Access Compliance Report

Public Rights-of-Way

Intersection ID: 42379	Main Street: CALLABRIDGE_CT	Cross Street: MT_HOLLY-HUNTERSVILLE_RD	Location: NE
ADA ID: 6BDA0C31C3EB	Ramp Type: BlendTrans1	Initial Pass/Fail: Pass	Overall Compliance: No
Severity Score: 9.25			
Codes/Mitigation Info/Possible Solution		Field Measurements/Component Compliance

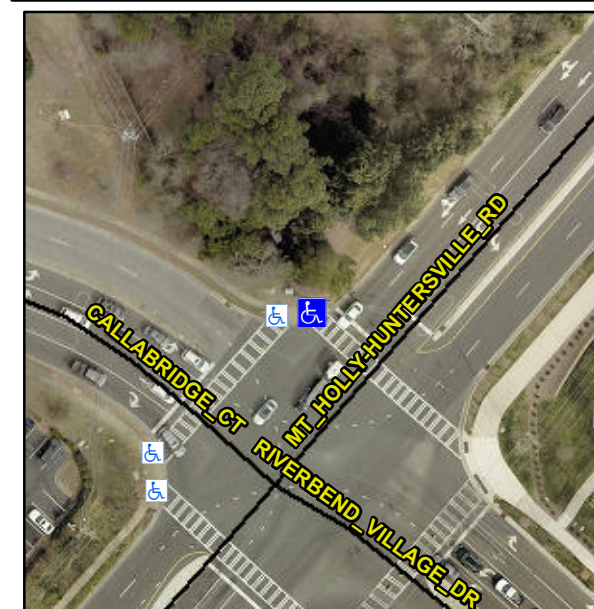
Remove & Replace Curb Ramp With Two New Directional Ramps or Equivalent. Remove & Replace Gutter.

R304.2.1, R304.2.2-Perp, R304.3.2-Para, R305.2, R304.5.4
